Re: Finance Docket No. 36284 - Seven County Infrastructure Coalition - Uinta Basin
Railway Project - Response to Information Request No. 5

**Seven County Infrastructure Coalition's Response to the
STB Office of Environmental Analysis February 24, 2020
Request for Information No. 5**

Figure 1 – Communications Tower Locations

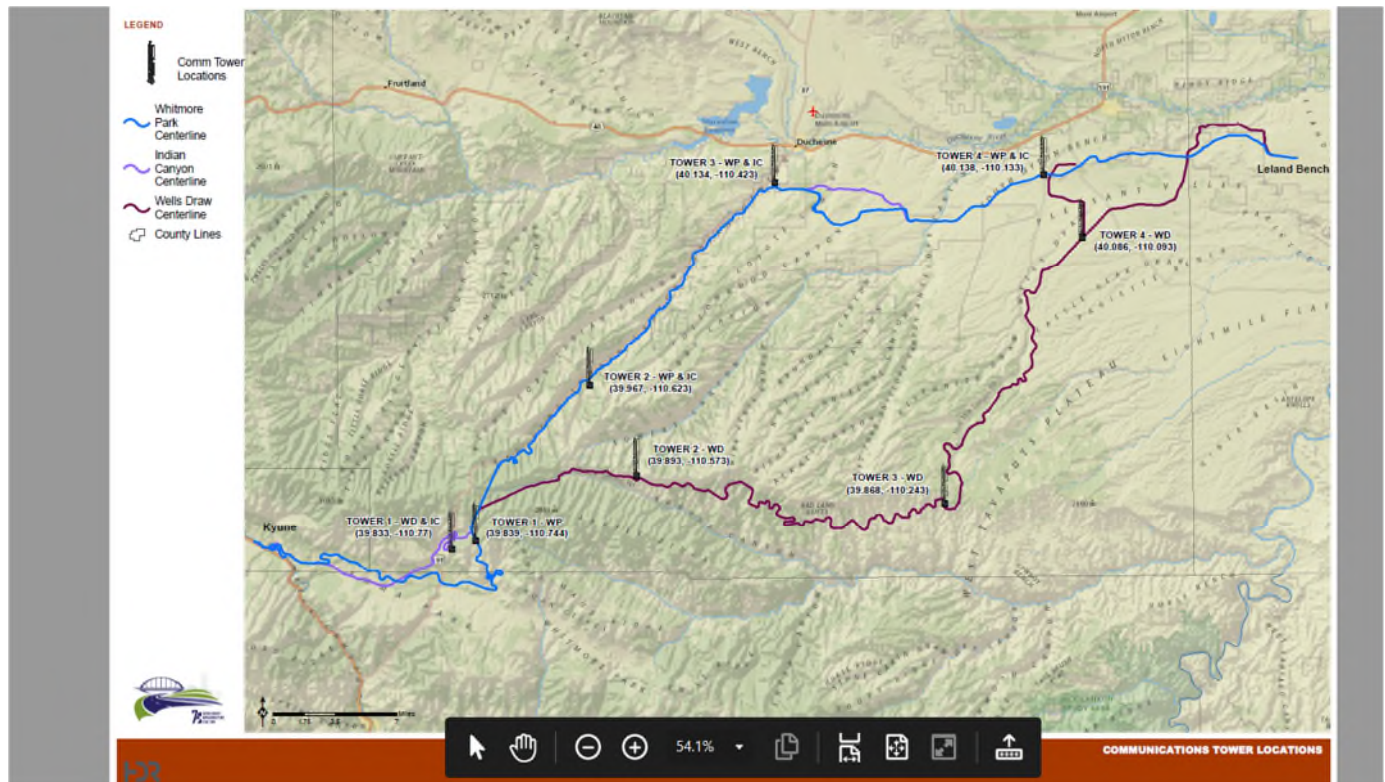
6. **OEA Request:** Please provide a corrected version of Table 1 that was submitted in response to Information Request #3. The previously submitted version of this table identifies some communications towers as being located within the proposed rail right-of-way, while the accompanying GIS data appears to show those towers as being located outside of the proposed rail right-of-way. The corrected table should provide accurate information regarding the locations of communication towers in relation to the proposed rail line.

Coalition Response: An updated version of Table 1 originally appearing in response to Information Request #3 is provided below. Some of the communications towers are anticipated to be located outside of the proposed right-of-way, as shown in Table 1 below.

Figure 1 below identifies the correct communications tower locations, which are also reflected in the GIS data uploaded to the UBRV project SharePoint site on March 9, 2020.

Figure 2 – Tunneling Construction

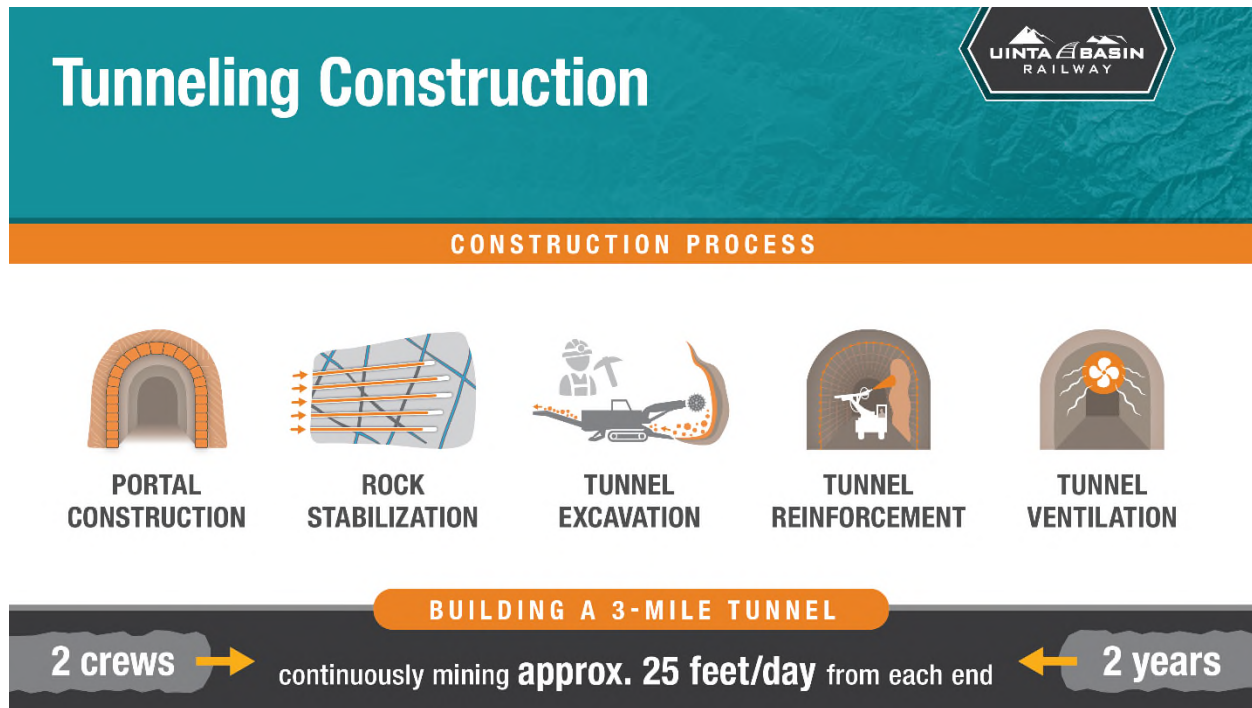
9. **OEA Request:** Please describe the method of tunnel construction that would be used to construct each of the proposed tunnels for each alternative.

Coalition Response: In general, the Coalition anticipates using a “mined” type method of tunnel construction for each tunnel location. However, drill and blast construction may be required for certain portions of tunnel construction, depending on the length and geological features of each tunnel location. It is anticipated that drill and blast construction may be necessary if sections of very strong rock are encountered.

Figure 2 below identifies proposed construction process for the 3-mile-long tunnel located near milepost 26 on each alignment. Tunnels up to 1 mile long may not require rock stabilization, depending on the geologic features encountered. Tunnels up to 1 mile long will not require ventilation.
